# Conceptual Review Agenda

Schedule for 08/25/14 to 08/25/14

# Fox Hills Annexation

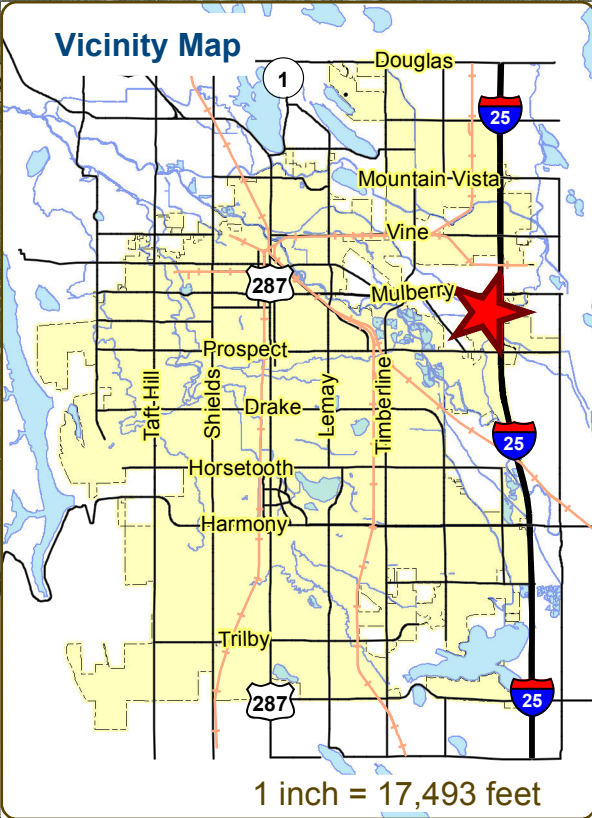
An annexation agreement signed when the Fox Hills PUD was originally approved has likely since expired and an annexation to Fort Collins would need to be initiated voluntarily by the subdivision land owners with the above-mentioned petitioning requirements.

The open space owned by the HOA can be counted to meet the 50%+ of the land to be annexed; however, as you also need 50%+ of the owners of the land to agree to the petition, this means a majority of lot owners will also need to agree to the annexation and their lands would likely already constitute the 50%+. The HOA president can sign the petition on the HOA's behalf, unless specified differently in the HOA covenants/bylaws.

# Site Plan

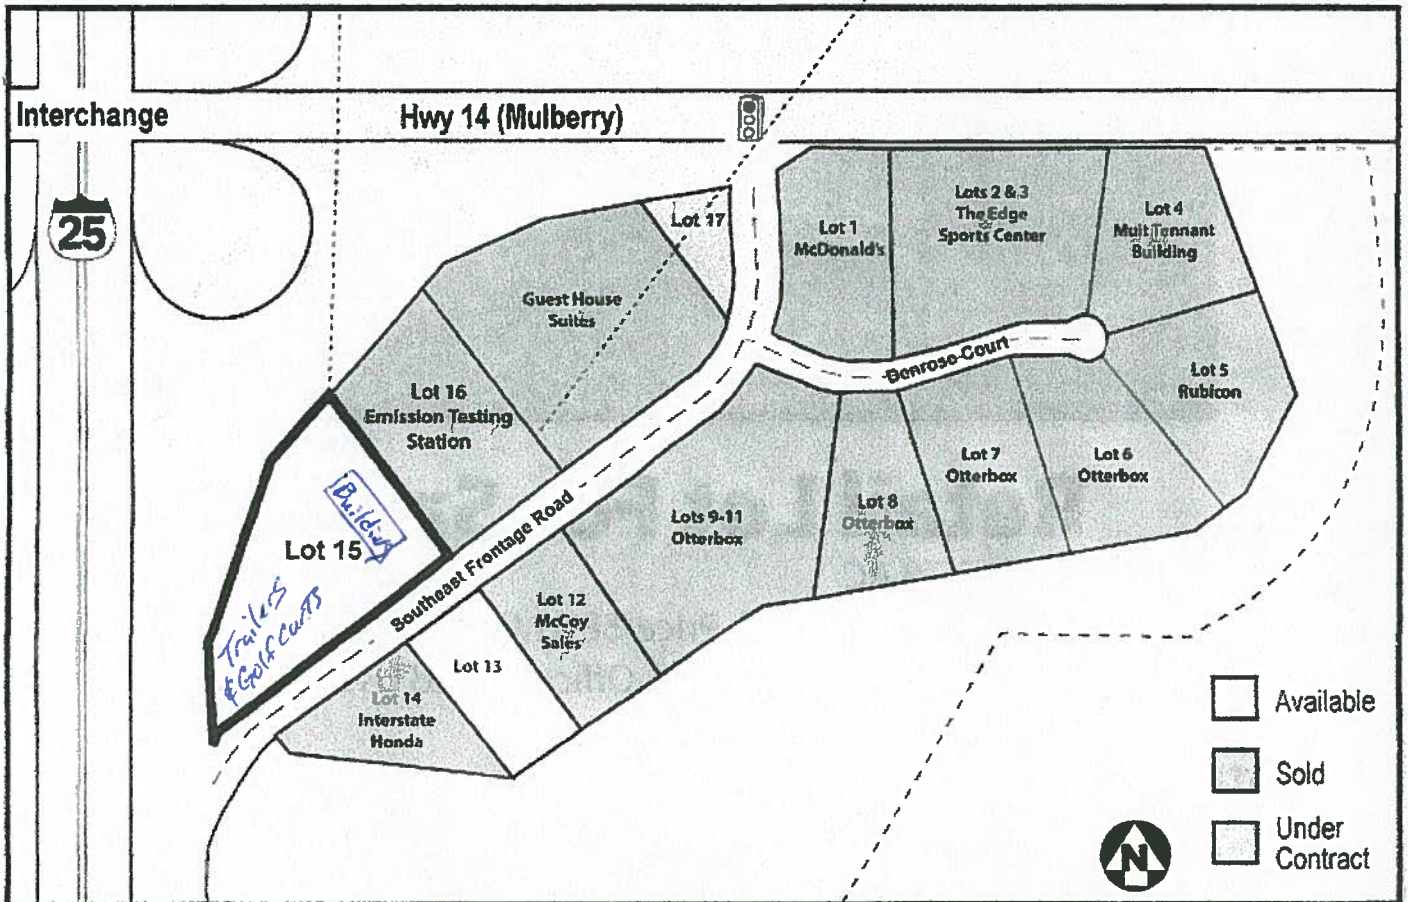
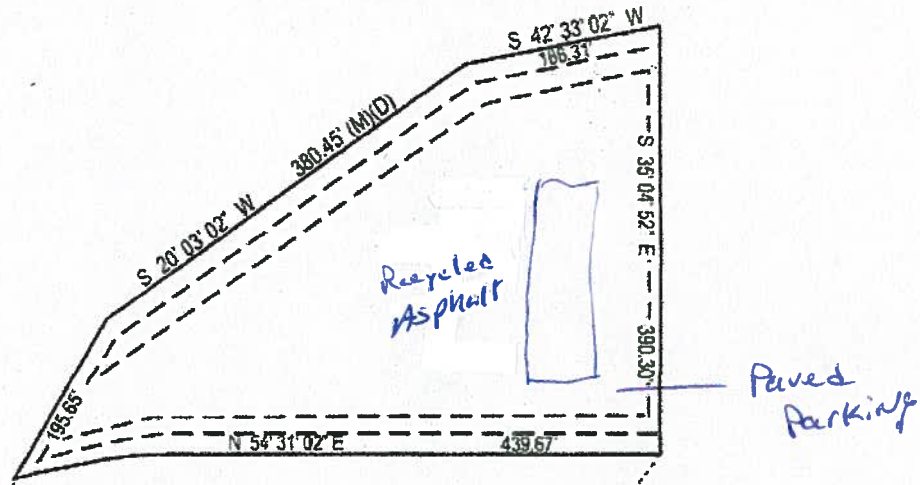
11. As we have discussed, it may be practical to consider phasing in the site development improvements due to the relatively large size of the parcel.
12. As you mentioned, the site would work best for trailers, if the internal access drive were looped with two driveways onto the Frontage Road. In conjunction with the comment from the Poudre Fire Authority, this loop could be dedicated as an Emergency Access Easement.

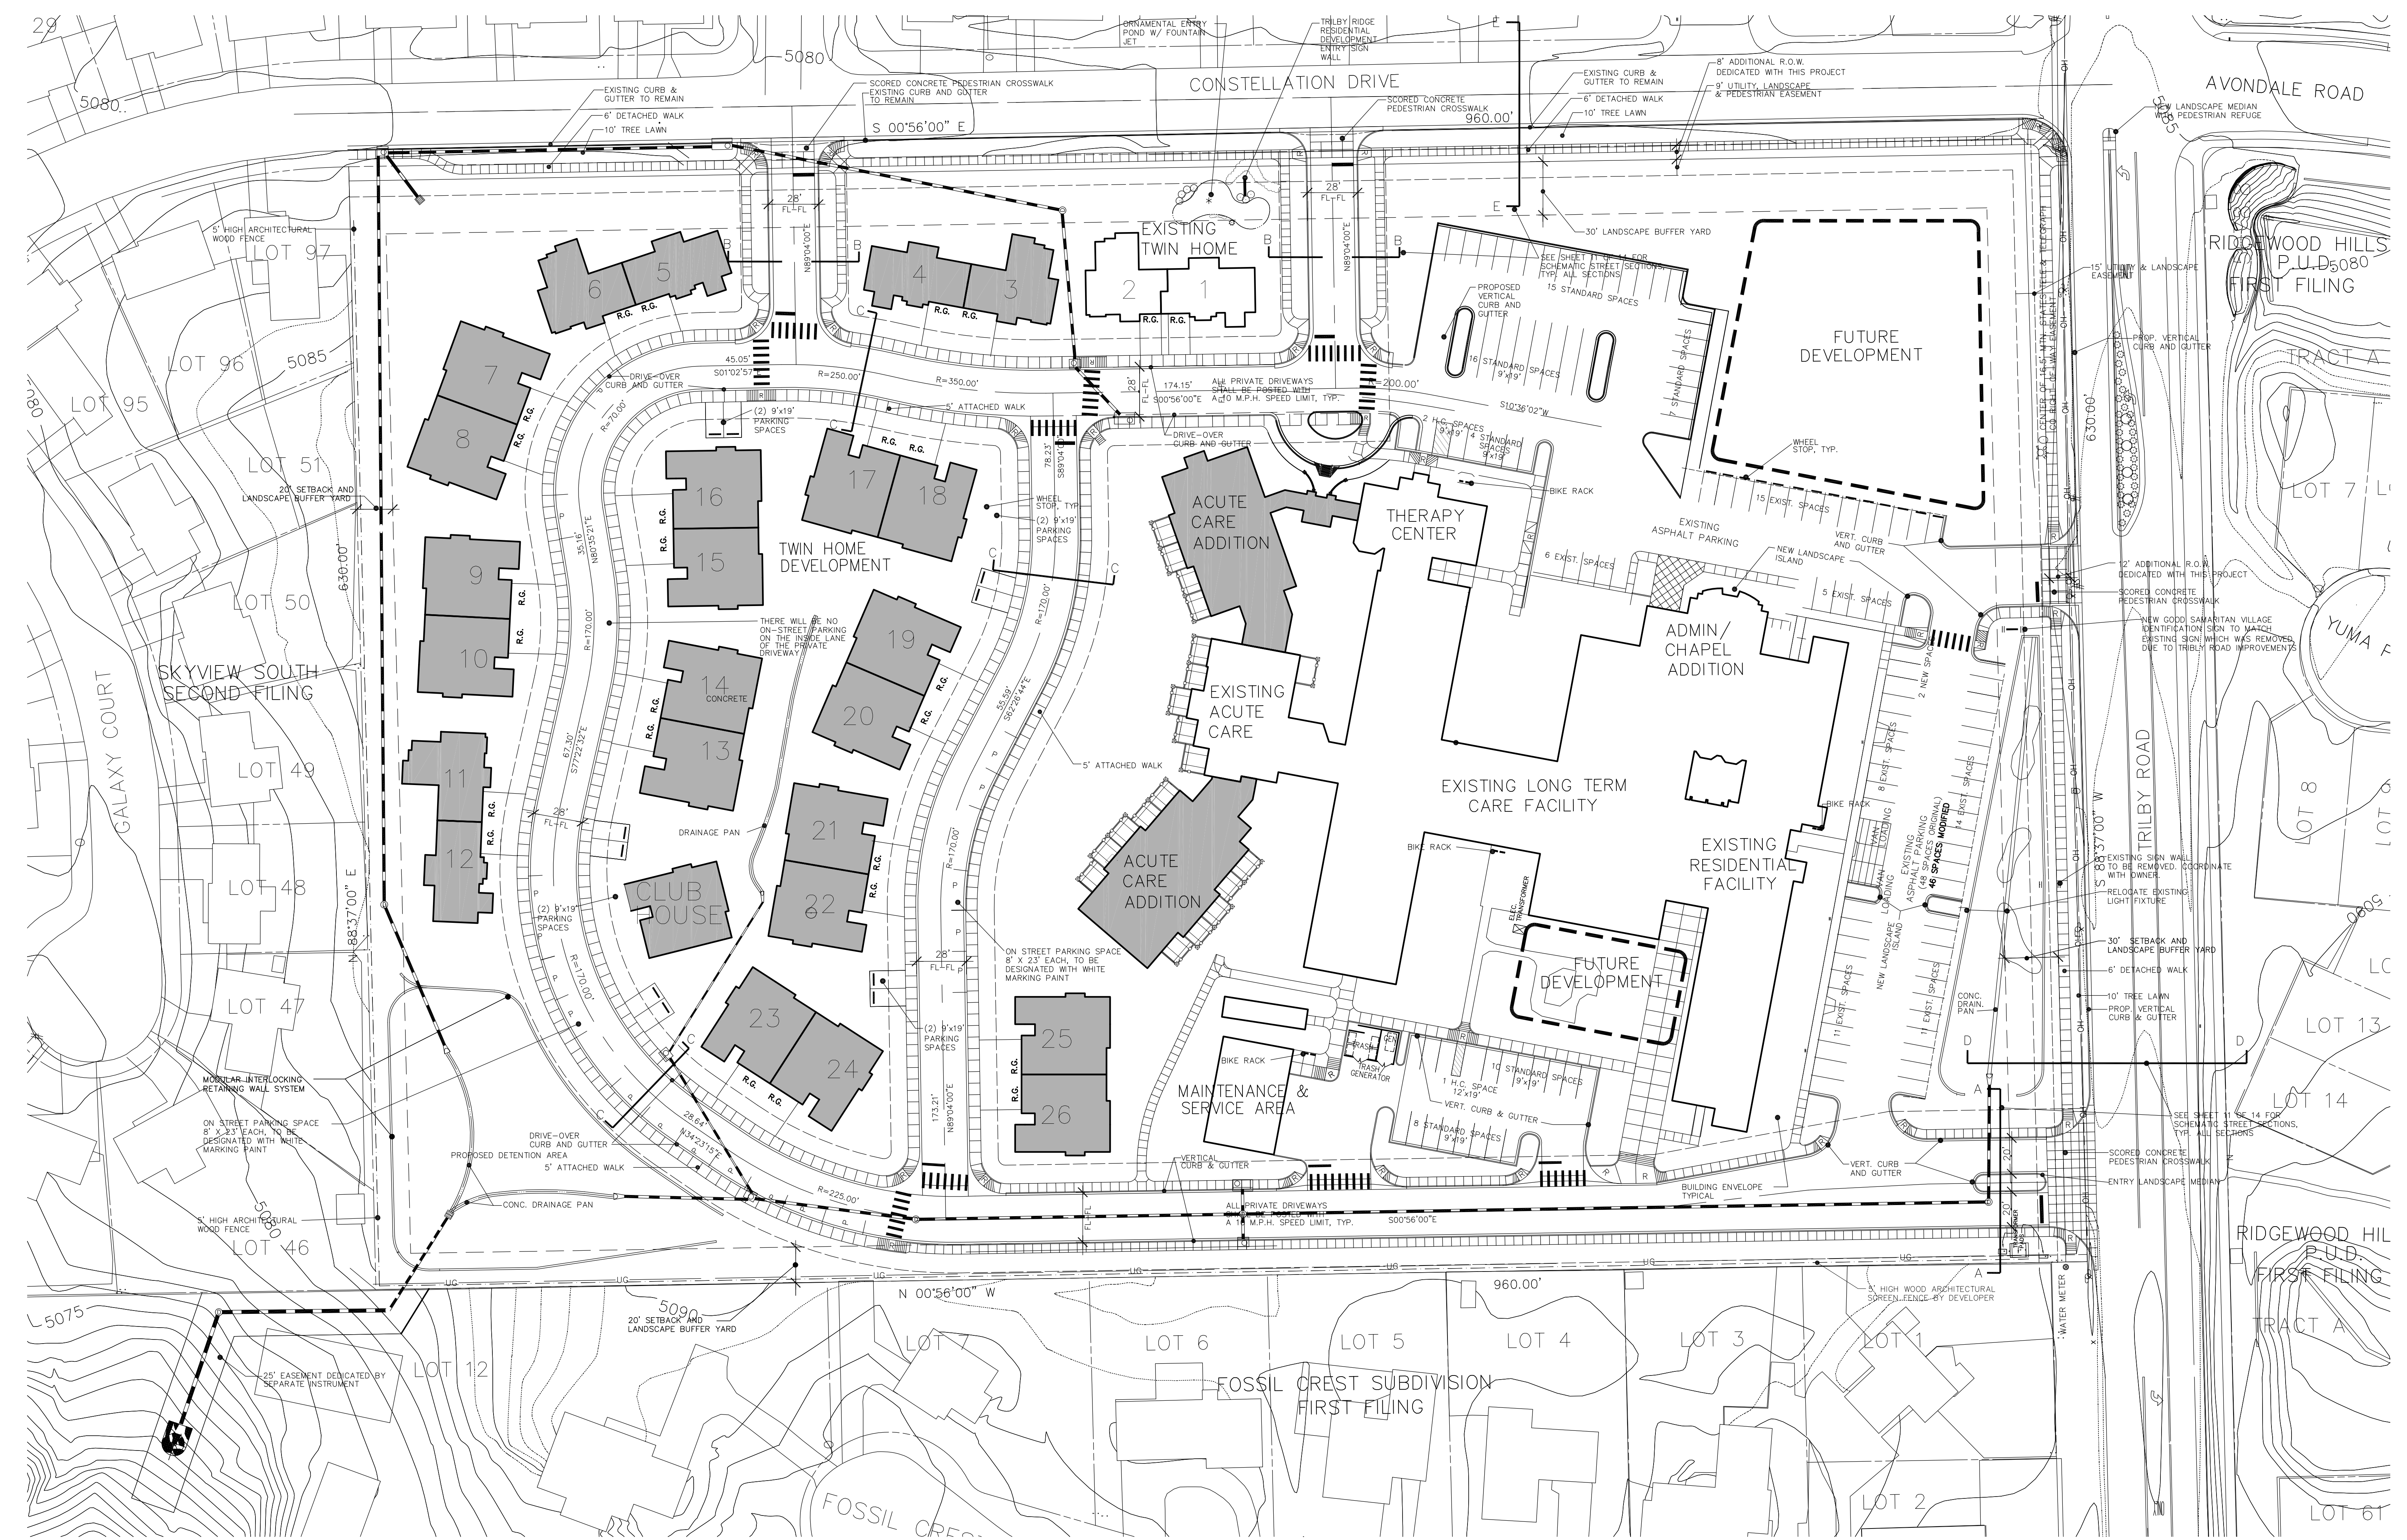
We would appreciate any comments the City of Fort Collins have related to this Concept Plan and would pose some specific questions:

- Will the ODP need to be amended to reflect the approach noted above? If so, can this be accomplished in conjunction with the PDP/FDP or must it be accomplished prior?
- The larger duplex units would reduce the originally proposed 32 units minimum to 26 units and density from 5.74 DU/ac to about 4.3 DU/ac. Would staff be able to support this change? Would support of this approach be tied to the re-evaluation of the Multi-Family Dwelling use and therefore an overall DU/ac for the entire campus?
- Would staff support the elimination of the Neighborhood Park and the greater square footage of the Acute Care wing?
- The original PDP proposed a detention pond at the northwest corner of the campus with release across an easement of the property owner to the west. In 1998, that property owner was

- Please comment on changes to development standards since approval of the original PDP that might affect street widths, utility development, storm water flows, fire protection, etc.
